Work Order ID 162249

Item Name: Strut

APICAL INDUSTRIES, INC.	ENGINEERING CHANGE NOTICE NO. 04274			SHEET 1 OF 1	
	DWG NO. 646.3500	REV: NC	PREPARED BY J. SOTO	DATE: 12/02/2013	EFFECT ON DWG ☐ INC. ☒ UNINC.
	DWG TITLE: STRUT				
	APPROVED BY: ENGR <i>[Signature]</i>	MFG <i>[Signature]</i>	QC <i>[Signature]</i>	EFF. NEXT ORDER	
TRANSACTION CODES (TC): A-ADD C-CREATE R-REVISE D-DELETE	REASON: REVISED DELTA NOTE 1 & 2.

APICAL
INDUSTRIES, INC.

SHEET 2 IS:

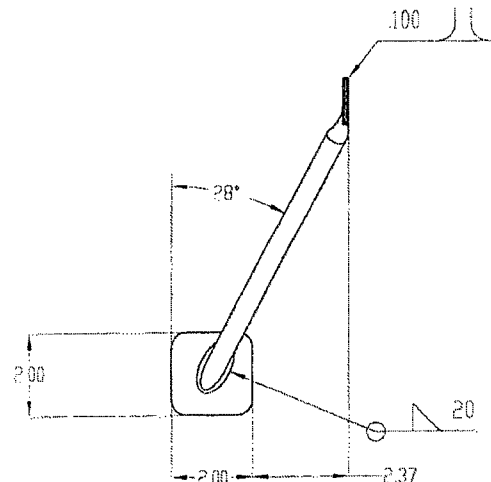
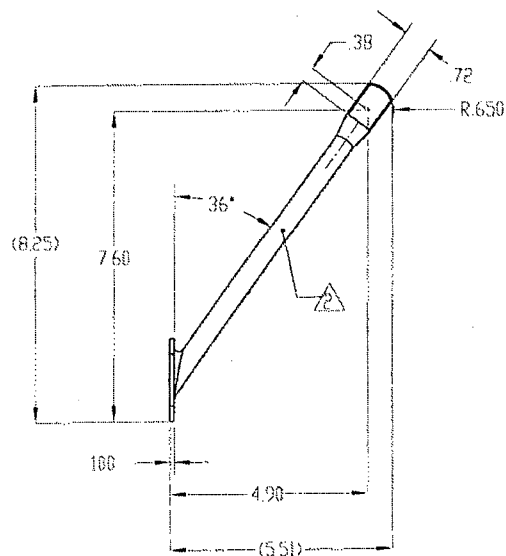
REASON: REVISED GEOMETRY TO ACCOMMODATE NEW EXISTING AIRCRAFT PROVISIONS

646.3512 SHOWN
646.3513 OPPOSITE

SHEET 2, IS:

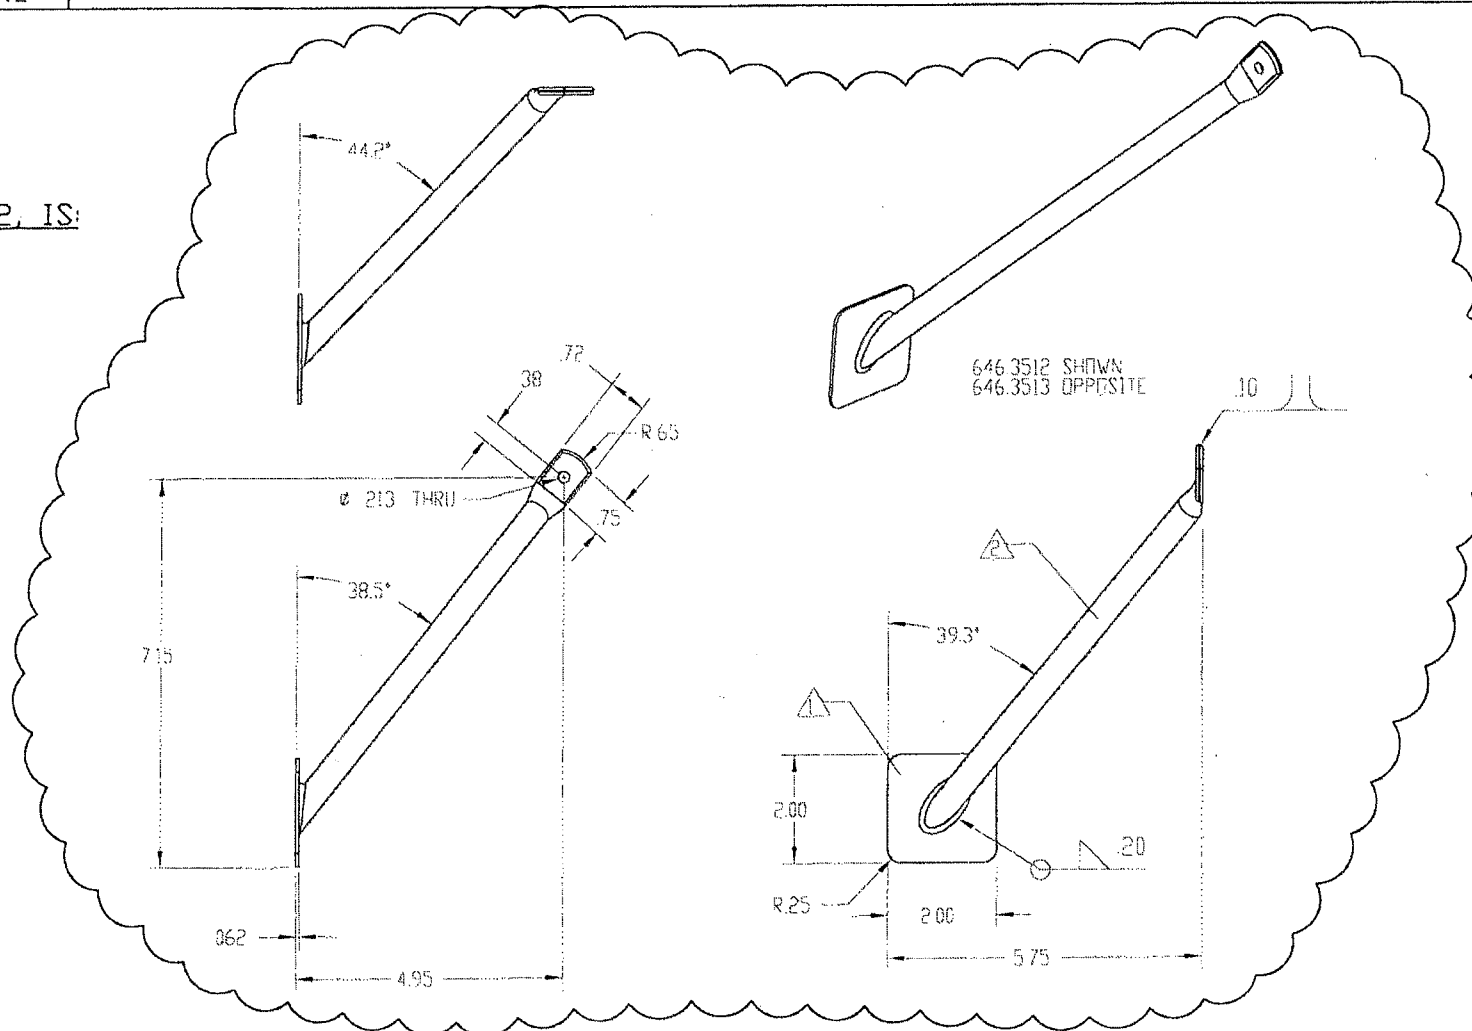
REASON: REVISED ANGLE OF 646.3512 & 646.3513 FOR BETTER FITMENT
